HANCOCK SUBDIVISION II

A REPLAT OF LOT 39, CHAPARRAL HILLS

IN THE NE 1/4 OF SECTION 36, T 11 S, R 67 W OF THE 6th P.M., EL PASO COUNTY, COLORADO

PCD FILE NO. VR254

as platted:

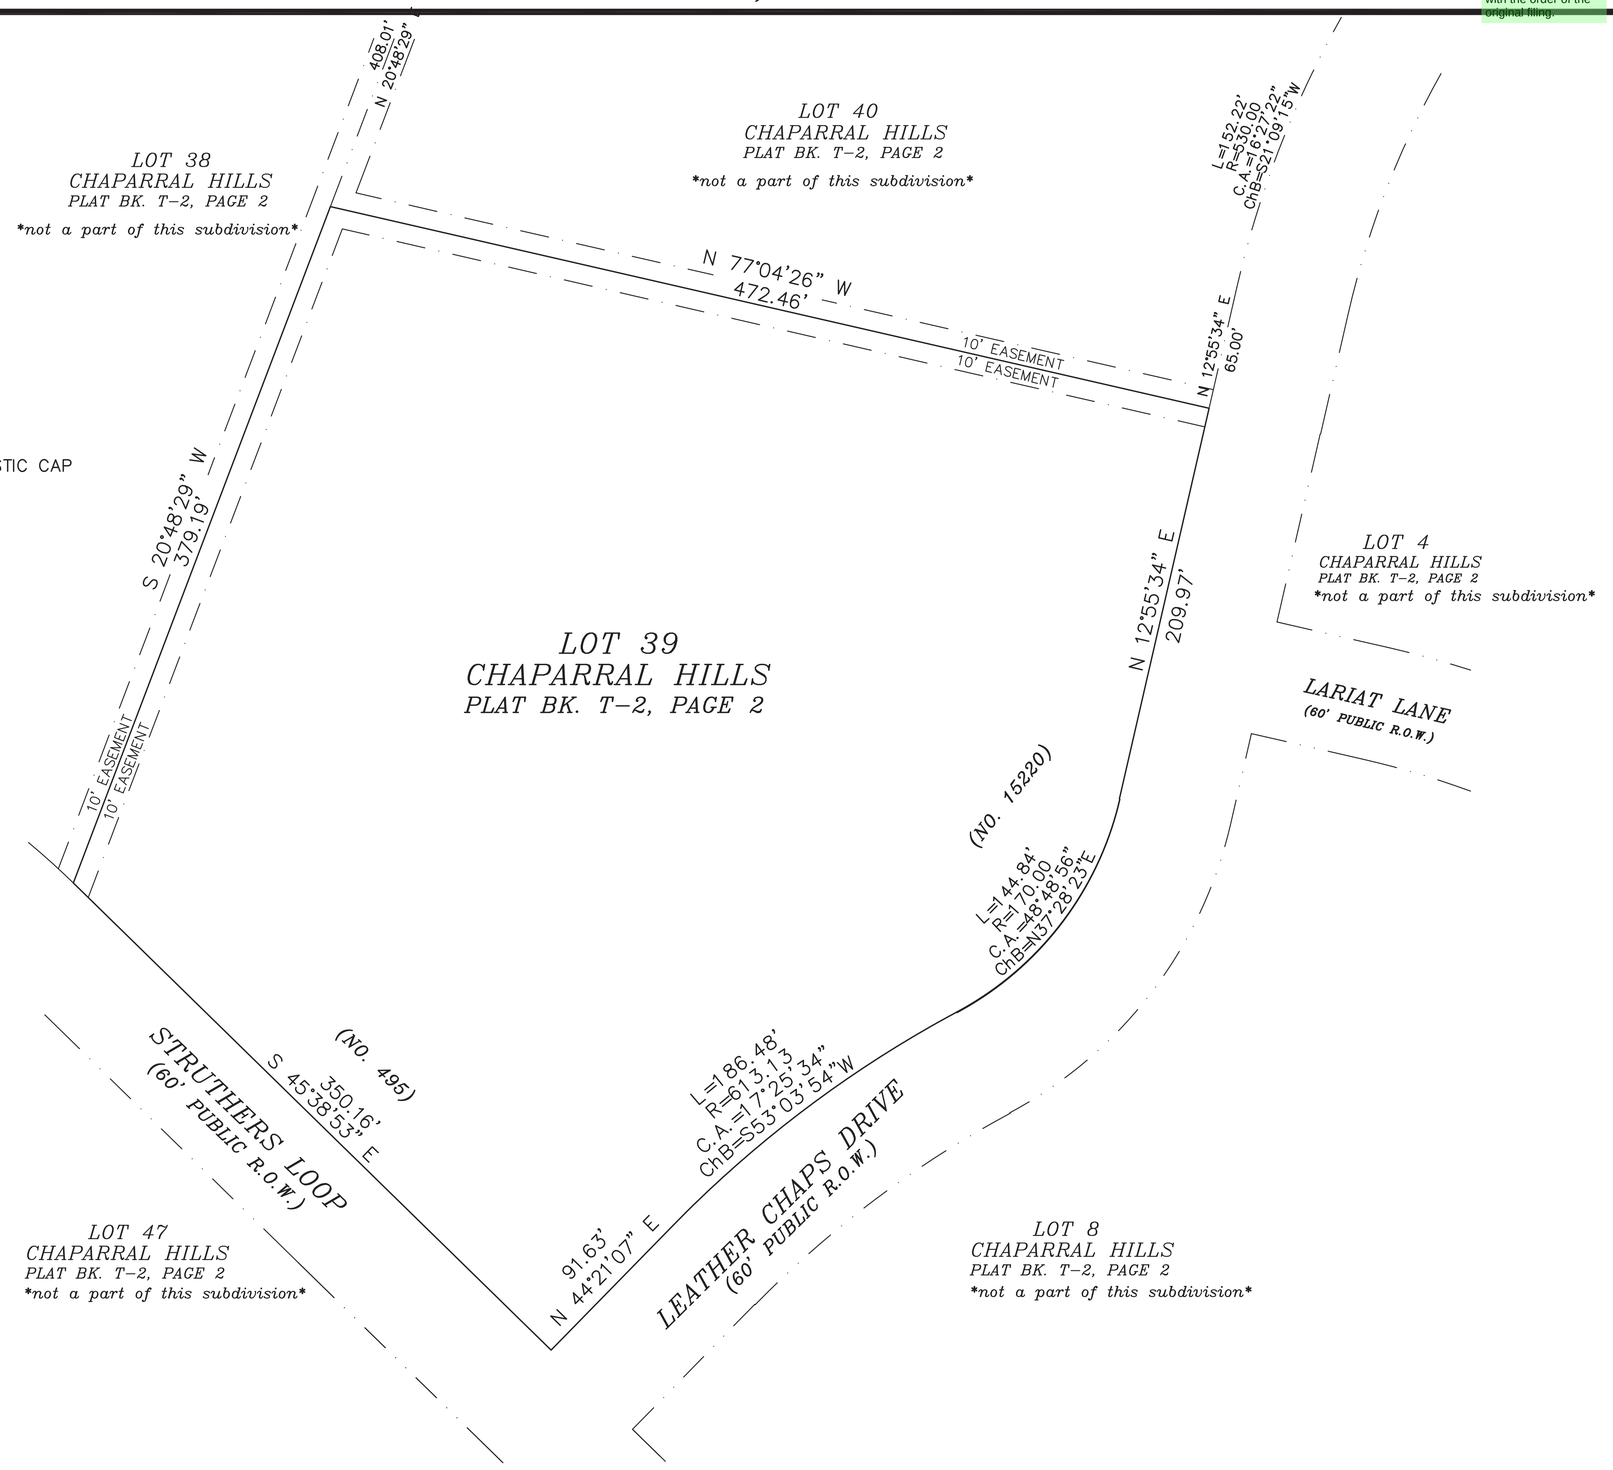
(6)Replat. Replat names shall be consistent with the name of the original plat filing unless the land includes more than 1 plat name, and characterized by an alphabetic descriptor after the filing number, and shall reflect consistency with the order of the original filing.

as replatted:

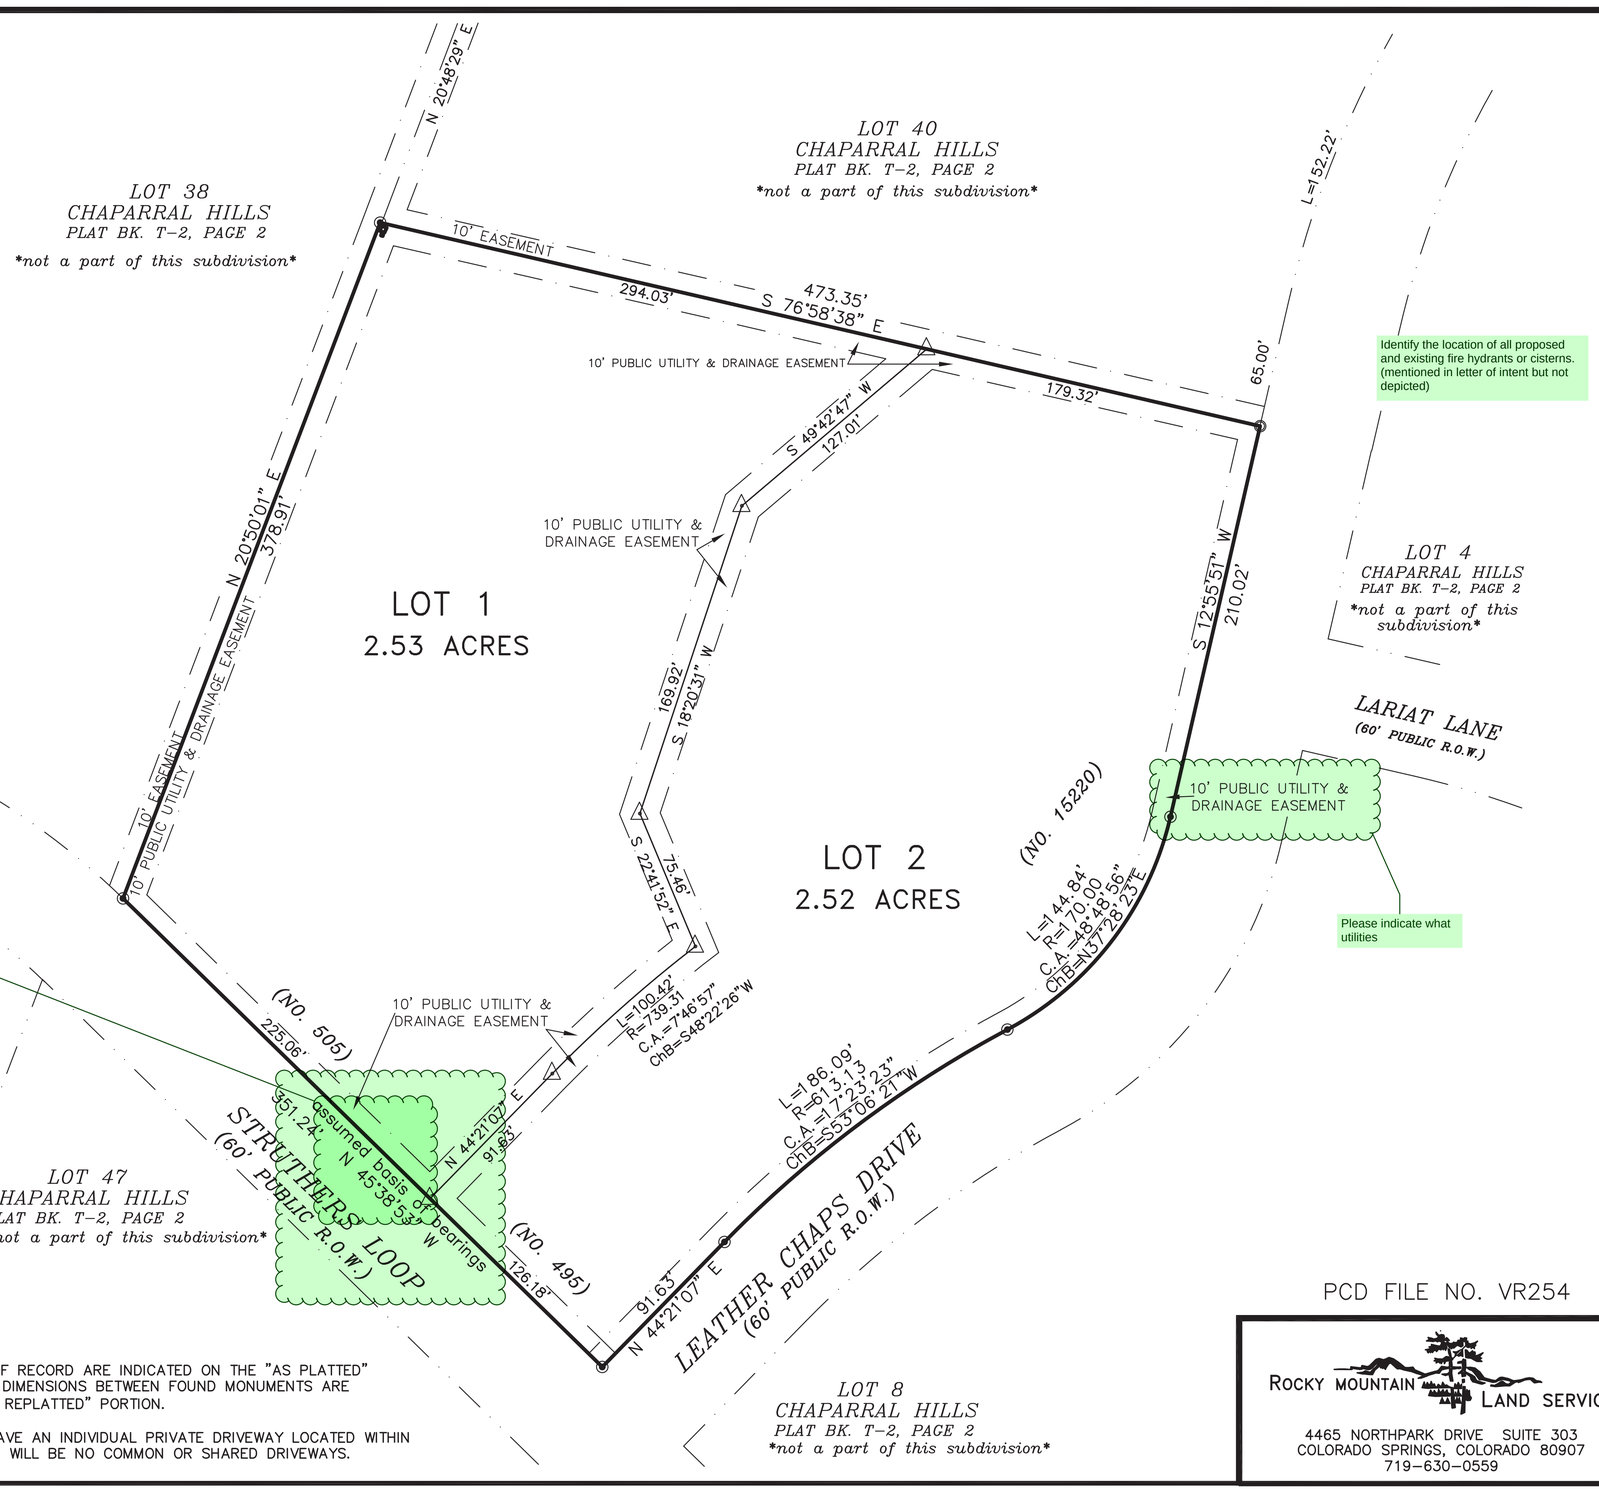
Missing:
- Identification of the point of beginning
- A statement by the land surveyor explaining the basis of bearing. Assumed bearings shall not be used. El Paso County subdivision regulations Basis of Bearings Statement shall follow the Bylaws and Rules of The State Board of Licensure for Architects, Professional Engineers and Professional Land Surveyors. This can be found at 6.8 Basis of Bearing Statement
- If no offset monuments are to be set in conjunction with the plat the following note shall be included on the plat: "Note: No offset monuments are to be set in conjunction with this plat."
- The final total gross acreage, the total number of lots. Gross density, net density and net acreage of the subdivision.
-

Identify the location of all proposed and existing fire hydrants or cisterns. (mentioned in letter of intent but not depicted)

Please indicate what utilities
